Agenda Item 3
780 Greenview Place
Limited Demolition
Family Room & Master Bedroom Addition

780 Greenview Place

Consideration of a request for approval of a limited demolition of portions of the residence to allow a rear, two story addition, an at grade patio, and additional landscaping in the affected area.

SITE PLAN

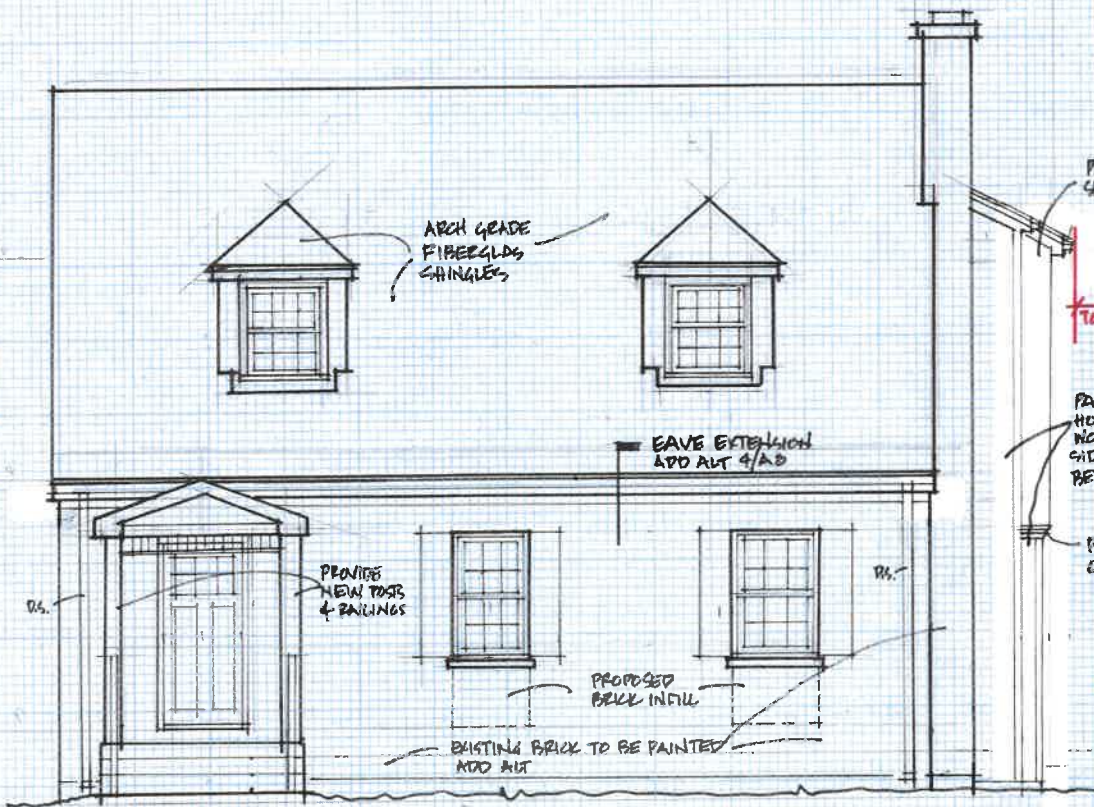
The modifications to the rear require the demolition of the existing two story addition. The footprint of the proposed addition will cover the demolished footprint and expand the home to the north and east. The existing home includes a chimney and a bay window along the east elevation before the proposed addition steps out roughly 2 feet 6 inches beyond the existing residence. At the point of furthest extent, the eave or edge of the gutter, the proposed addition will be nearly 11 feet from the east property line and compliant with the interior side yard setback requirements. The property directly to the east is a reversed corner lot that fronts Wooded Place with the rear yard of the property adjacent to the east side yard of the subject property. The proposed two story addition will present a significant mass adjacent to the private area, the rear yard, of the neighboring home.

A rear covered porch will provide access to the proposed mudroom at the northwest corner of the addition. The existing rear patio will be demolished and a new at grade patio will expand out from the existing location to the adjacent driveway to the west. No changes are proposed to the driveway or garage.

REAR (NORTH) ELEVATION
3/8" = 1'-0"

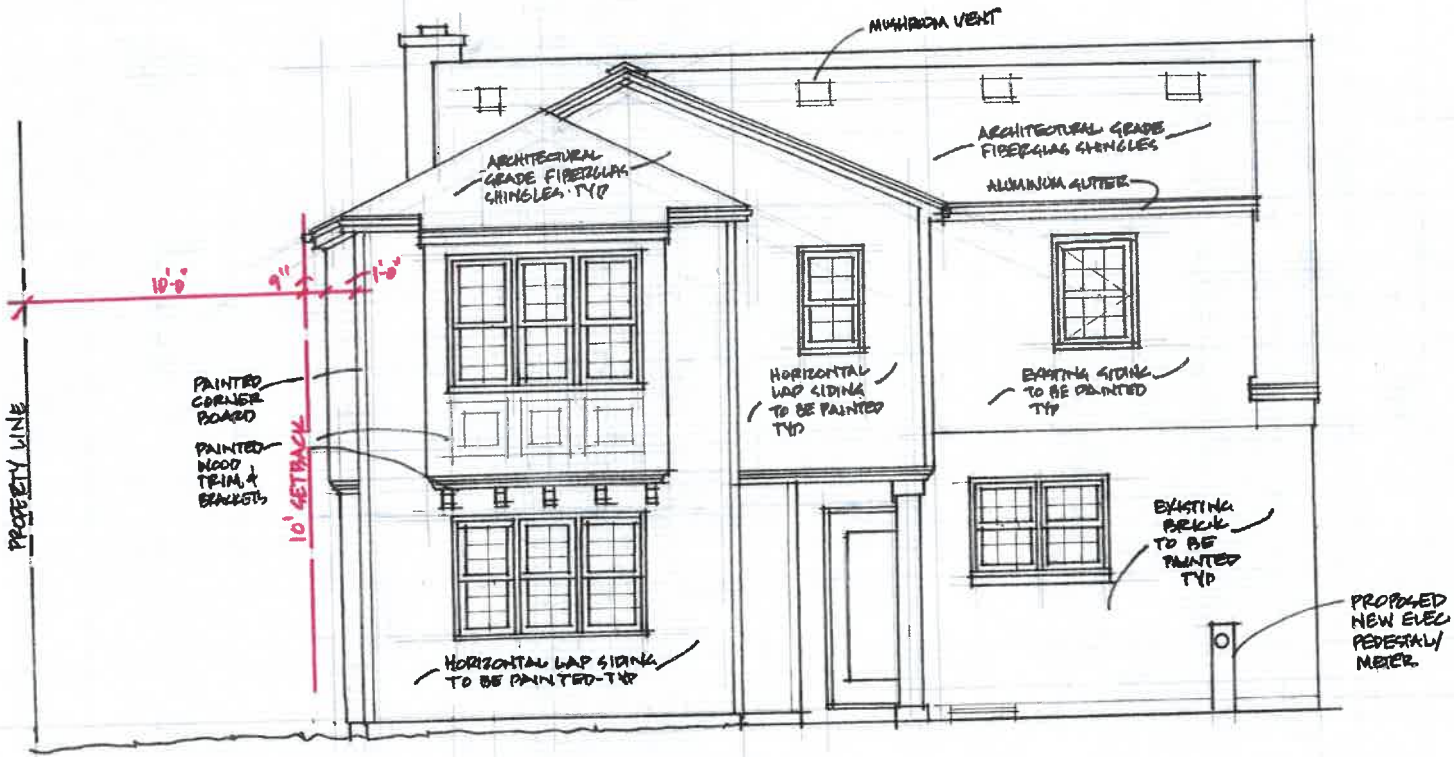
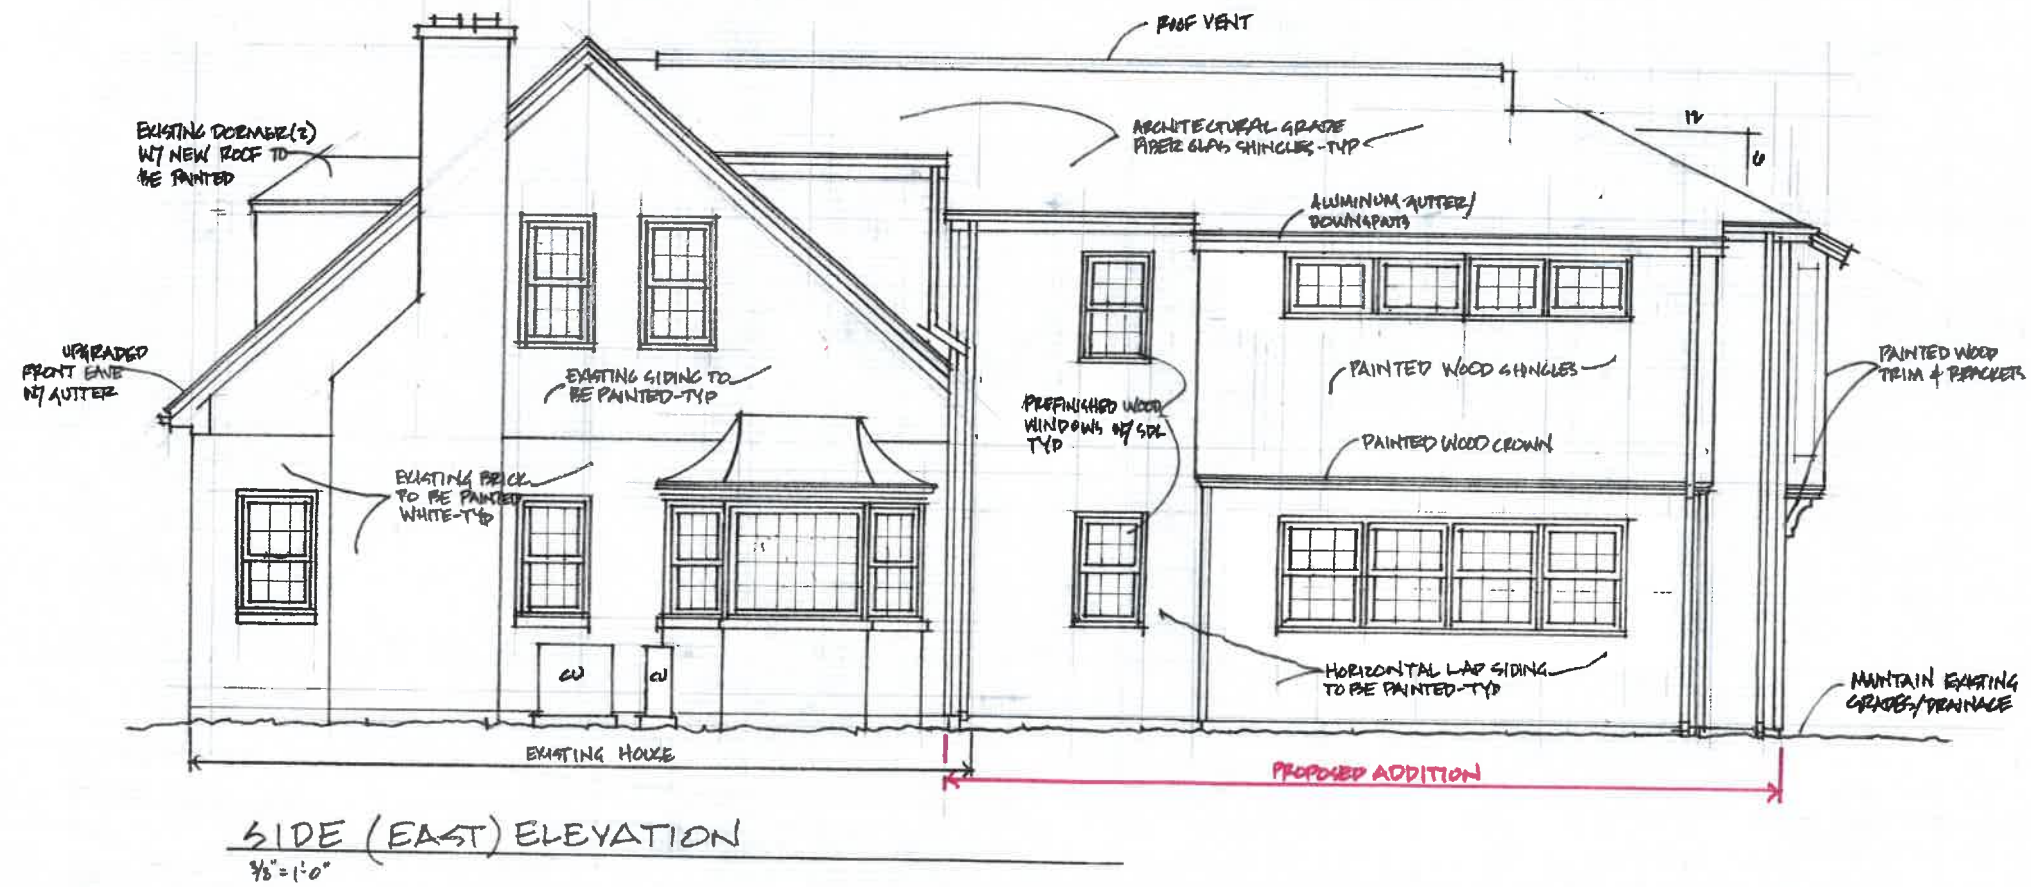
A second story bay window is located above the first floor set of windows on the portion stepped out furthest into the rear (north) yard and is supported by wood brackets. The house steps in with a single double hung window located above the covered porch which features a singular column at the corner and provides access to the mudroom. The existing home steps in further to allow for the reconfigured at grade patio.

The side (west) elevation features a set of double doors on the first floor to provide access to the rear patio. There is a balance of solid wall to window openings on all three elevations. The windows are evenly placed. While the four windows on the second floor of the east elevation are of a different size than windows found elsewhere on the home, the location of the wall in relation to the neighboring property and residence, supports this deviation in window sizing.
